Service Bulletin

Bulletin No.: PI1176

Subject: AWD OFF Message Displayed in DIC or CODE 73 or CODE 173 Illuminated in DIC

Models: 2013-2014 Buick Encore
2013-2014 Chevrolet Trax (Canada)
Equipped with All Wheel Drive (AWD)

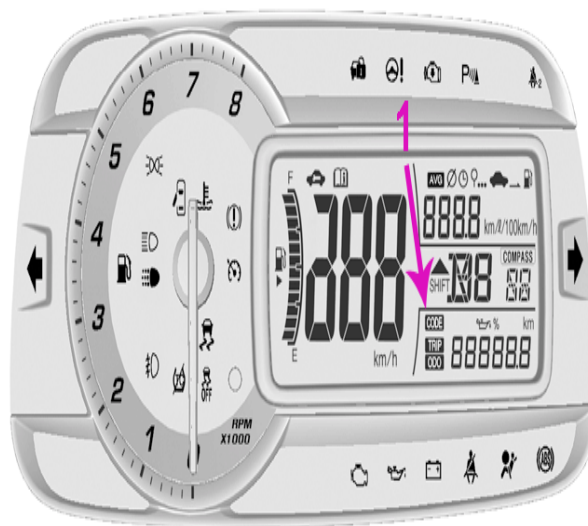
Notice: The word CODE (1) on the DIC will illuminate and then be followed by the number 73 or 173.

4. For the Chevrolet Trax, observe the DIC for CODE 73 or CODE 173 being displayed.
⇒ If CODE 73 or CODE 173 is displayed in the DIC, Go to Step 5.
5. Reprogram the Rear Differential Control Module using the latest available software. Refer to Rear Differential Control Module Programming and Setup in SI.
